ADDENDUM NO. 1  
TO THE CONTRACT DOCUMENTS

Date: August 4, 2023  
Project No.: D3571200

**MILLEY'S CREEK WPCP SCREEN REPLACEMENT PROJECT**

THE WATER WORKS AND SANITARY SEWER BOARD  
CITY OF MONTGOMERY

VERIFY SCALE	BAR IS ONE INCH ON ORIGINAL DRAWING.
DATE	JULY 2023
PROJ	D3571200
DWG	05-Y-201
SHEET	09 of 32

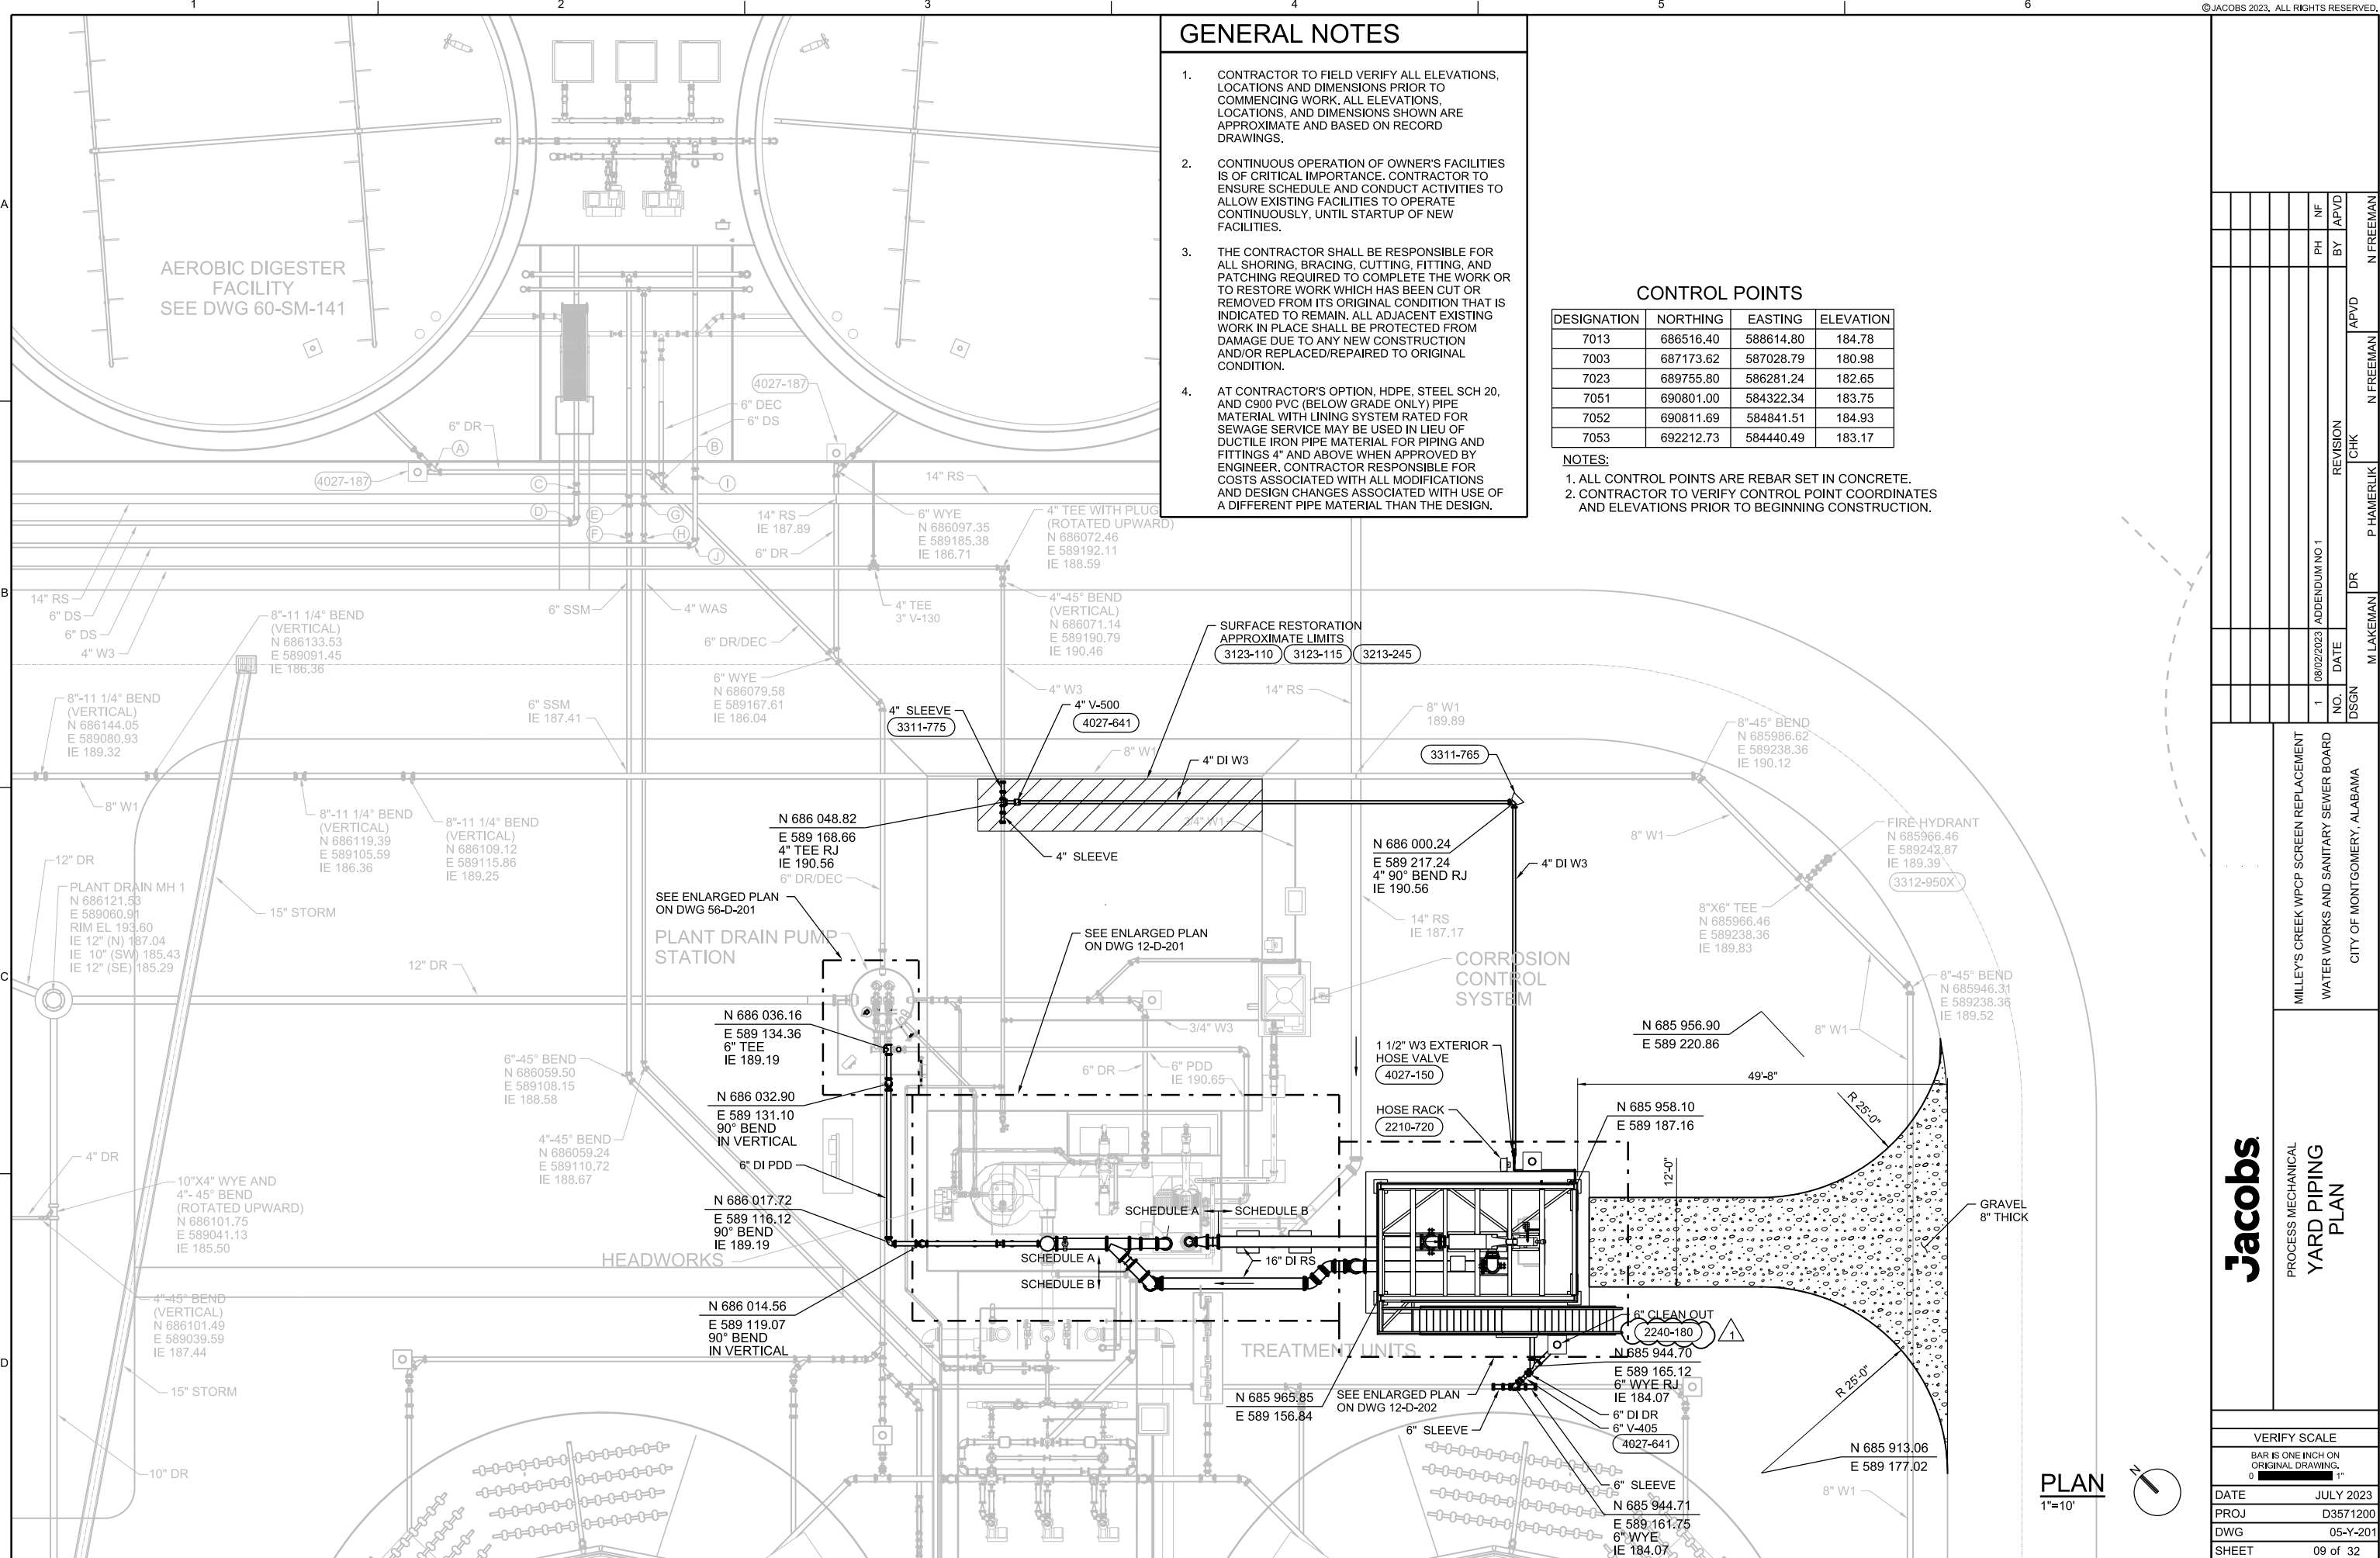
1. REMOVE Drawing 05-Y-201 in its entirety and REPLACE with the attached.
2. REMOVE Drawing 12-D-202 in its entirety and REPLACE with the attached.
3. REMOVE Drawing 12-D-301 in its entirety and REPLACE with the attached.

DATE	JULY 2023
PROJ	D3571200
DWG	12-E-201
SHEET	19 of 32

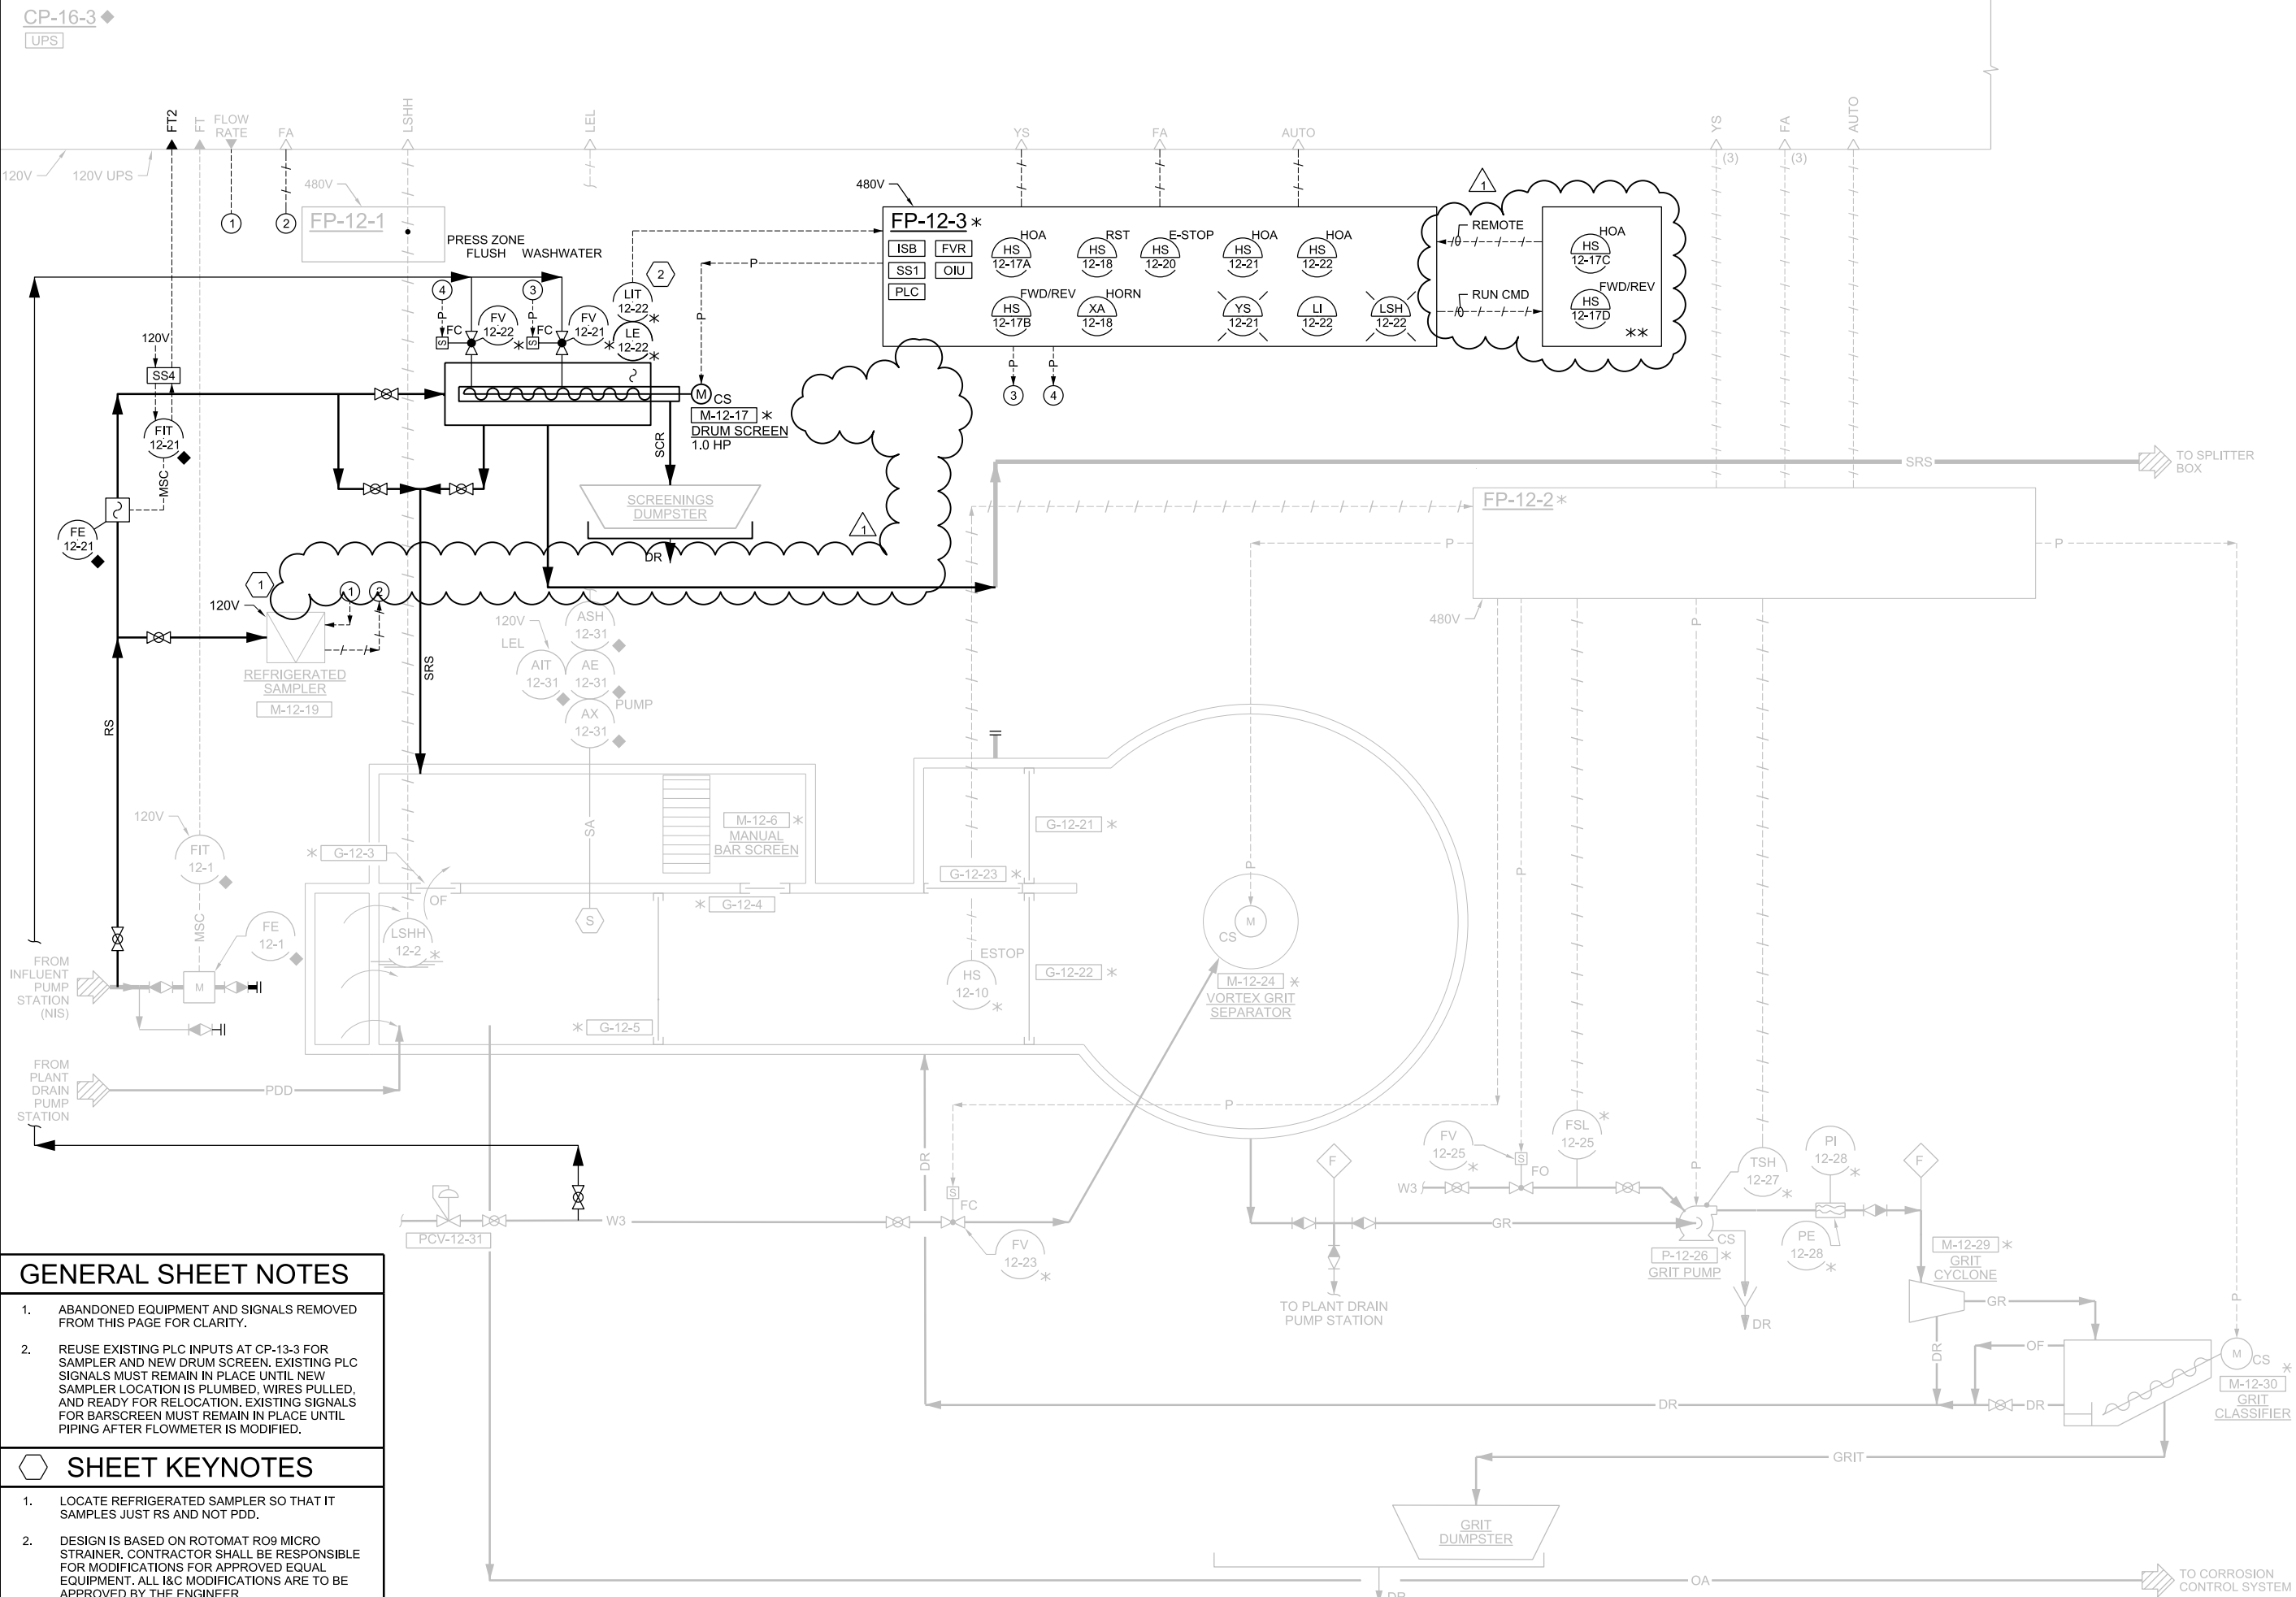
4. REMOVE Drawing 05-E-201 in its entirety and REPLACE with the attached.
5. REMOVE Drawing 05-E-601 in its entirety and REPLACE with the attached.
6. REMOVE Drawing 05-E-602 in its entirety and REPLACE with the attached.
7. REMOVE Drawing 12-E-201 in its entirety and REPLACE with the attached.
8. REMOVE Drawing 08-N-602 in its entirety and REPLACE with the attached.
